**NOTICE OF SERVICE OF IGWA'S
RESPONSIVE EXPERT REPORTS
AND SUPPORTING DATA
REGARDING IDWR STAFF
MEMORANDUM**

Response to
Staff memorandum in response to expert reports submitted for Rangen Delivery Call

Response to "Staff memorandum in response to expert reports submitted for
Rangen Delivery Call (In the Matter of Distribution for Water to
Water Right Nos. 36-02551 and 36-07694)"

Figure A.1 – Trimline Comparisons ESPAM2.0 and 2.1 (Revised Figure 4.10)

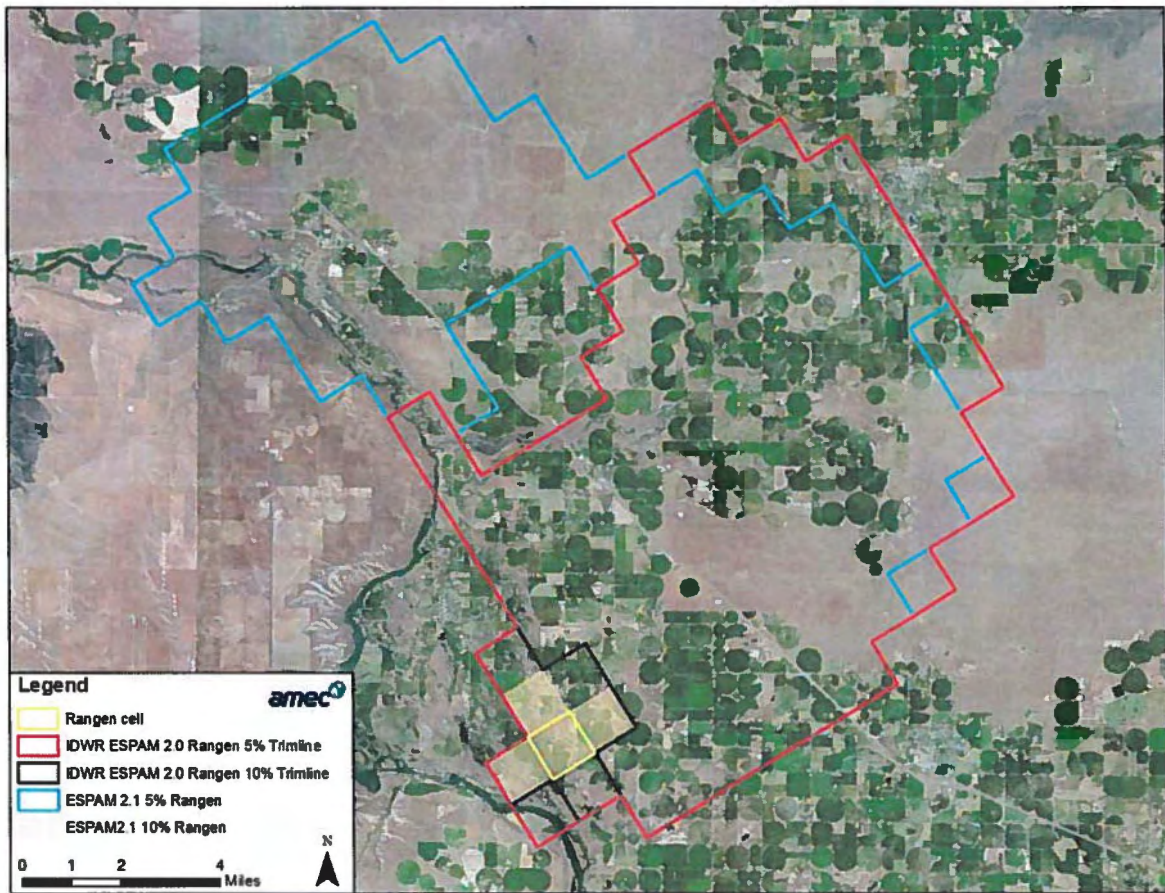
On page 38, the staff memo contains the following statement regarding AMEC’s use of the 10% trimline: “It appears that Dr. Brendecke did not use the correct 10% trimline in his analysis performed with ESPAM2.1. AMEC’s model files show that pumping was applied in model cells 1041014 and 1043013, which both have steady state response functions of 9.53% with respect to the Rangen spring complex.”

This error occurred because I allowed steady state response values greater than 9.5% to be rounded up to 10% before defining the trimline, whereas IDWR does not consider such rounding. Attachment A contains the relevant tables and figures from my report that reflect this correction.

Figure A.1 is updated from Figure 4.10 in my 12/21/2012 expert report. The corrections shown in this figure are updated 5% and 10% ESPAM2.1 trimlines.

Figure B.1 – Trimline Comparisons ESPAM2.1 and AMEC Alternative Model

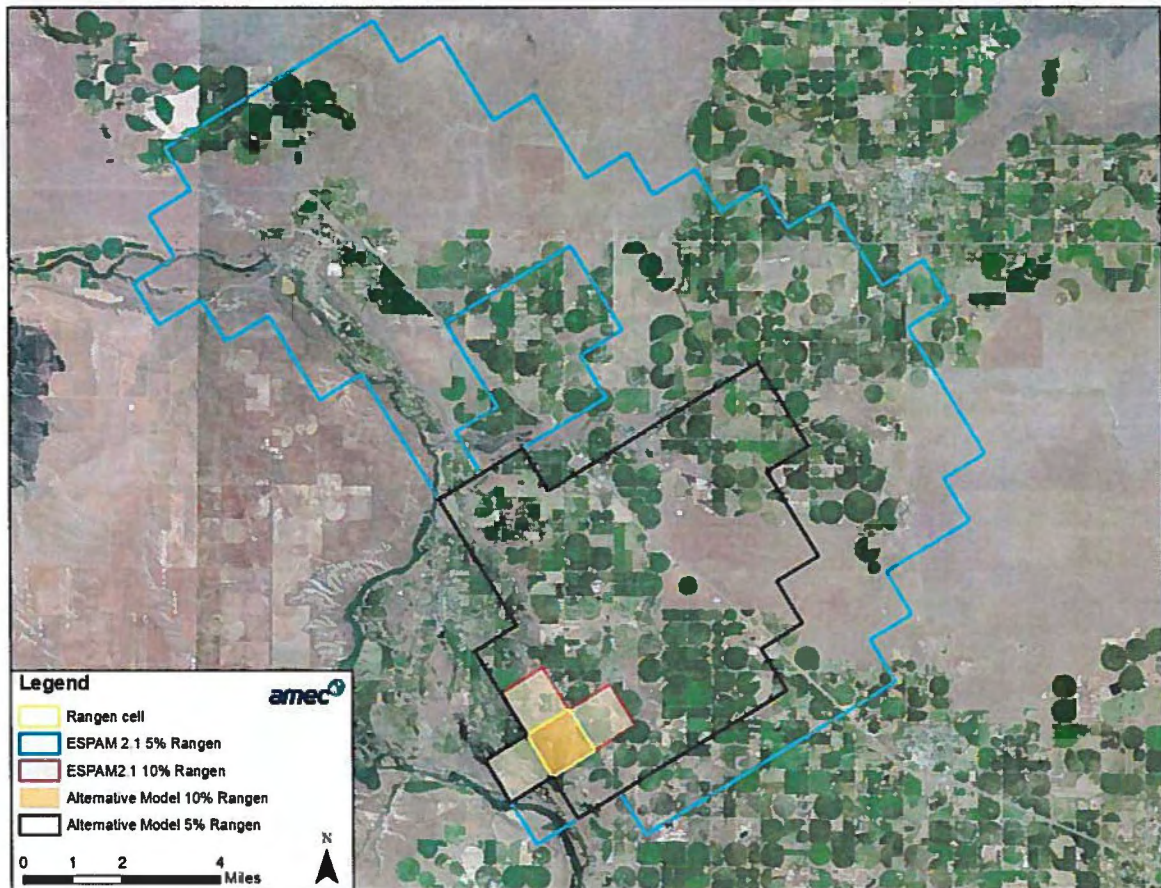
On pp. 38-39 of the staff memo, IDWR staff present an evaluation of alternative models presented in my December report. Among other things, they ran the alternative models for a scenario of full curtailment across the model domain. I believe this full domain curtailment scenario to be an inappropriate use of the alternative models as they were recalibrated only for parameters in the CRIV group, which includes drain, river bed and general head boundary conductance parameters. The alternative models were not recalibrated for transmissivities anywhere in the model domain. As a result, the regional pathways of groundwater flow toward

Figure B.1 is similar to Figure A.1. It compares the trimlines generated by ESPAM2.1 and the AMEC recalibrated alternative model.
